**NOTICE OF DECISION TO CONSENT TO AMEND A REFERRED PROPOSAL
DURING ASSESSMENT**

Australian Vanadium Project – Mining and Beneficiation Operations
Assessment No.2287

Attachment 1- Amended proposal content document and figure/s showing the amendments

Figure 1.4 Groundwater Impact Zones

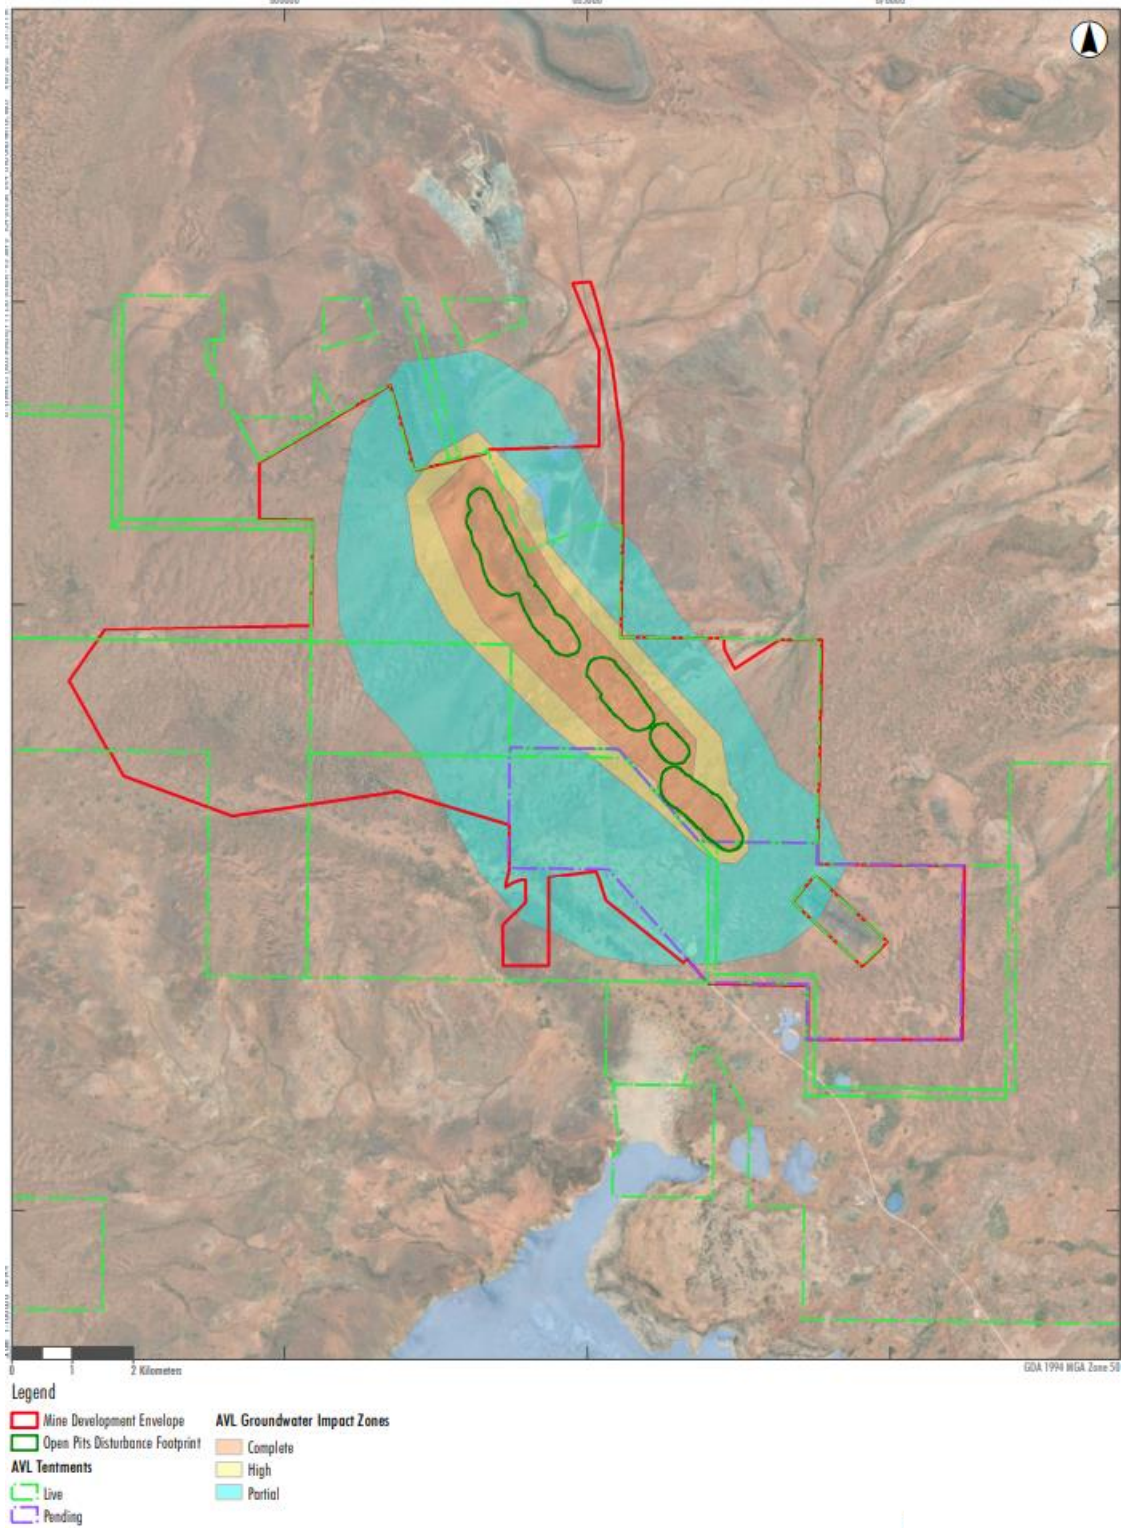
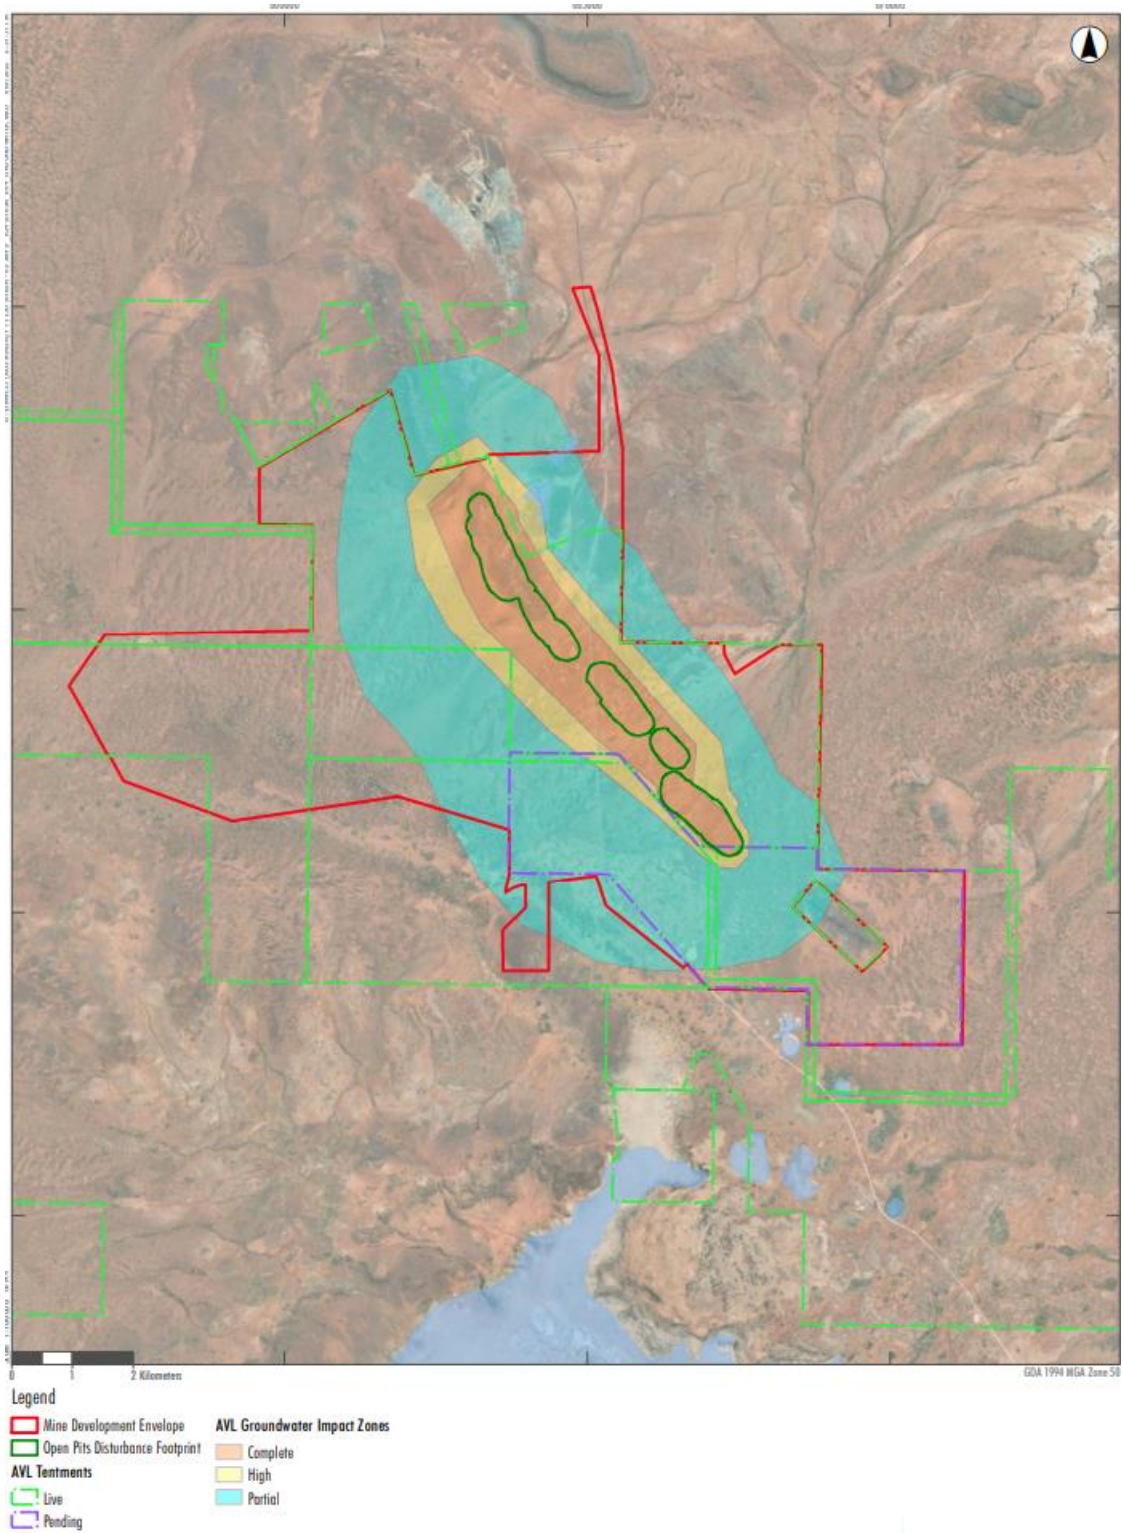
Element	Original Proposal	s.43a (Amended Proposal)
Meekatharra-Sandstone Rd Diversion	Clearing of no more than 6 ha of native vegetation within the 15 ha Diversion Development Envelope	Removed.
Access Road and Infrastructure Corridor	Clearing of no more than 1,100 ha of native vegetation within the 2,625 ha Infrastructure Corridor Development Envelope.	Clearing of no more than <u>670 ha</u> of native vegetation within the 2,625 ha Infrastructure Corridor Development Envelope.
Pipeline corridor	-	<u>Clearing of no more than 47 ha of native vegetation within the 2,430 ha Pipeline Corridor Development Envelope.</u>
Open Pits	The open pits cover a combined maximum surface area 350 ha within the Open Pits Disturbance Footprint.	<u>The maximum depth of the open pits is 250 mAHD.</u>
Groundwater Abstraction	Groundwater abstraction of no more than 3 GL/a.	Groundwater drawdown as a result of implementing the proposal: <u>Groundwater drawdown (groundwater depth compared to baseline groundwater level prior to commencing groundwater abstraction) does not extend:</u> <ul style="list-style-type: none"> • <u>beyond 10 m of groundwater drawdown;</u> and • <u>outside of the High Groundwater Impact Zone.</u> <u>Outside of the Partial Groundwater Impact Zone, groundwater drawdown remains less than 2 m.</u>

The proposed amendments more accurately reflect updated hydrogeological modelling predictions. Key changes to the groundwater model include updated hydraulic conductivity, increased percentage of rainfall recharging the groundwater, and interflow through shallow soil profiles which results in increased recharge compared to the previous model. Excess water is proposed to be reinjected to the deep aquifer within the boundary of the MAR reinjection borefield and/or discharged via pipeline to Lake Annean.

Proposal element	Location description /	Maximum extent, capacity or range
		<p>outside of the High Groundwater Impact Zone</p> <ul style="list-style-type: none"> • Outside of the Partial Groundwater Impact Zone groundwater drawdown remains less than 2 m.
Reinjection to Groundwater	Figure 1.1	Reinjection of up to 4.4 GL/a water to the deep aquifer within the boundary of the reinjection borefield. Quality of the reinjected water may range from brackish to hypersaline.
Discharge of excess water to Lake Annean	Figure 1.1	Discharge of up to 2.6 GL/a of water to Lake Annean via pipeline. Quality of the discharged water may range from brackish to hypersaline.
Beneficiation Waste	Figure 1.1	Disposal of no more than 920,000 tpa of tailings solids into the Integrated Waste Landform tailings cells.
Proposal elements with greenhouse gas emissions		
Peak Annual Average:		
Scope 1	Mine Facility: 63,775 t CO ₂ e per annum
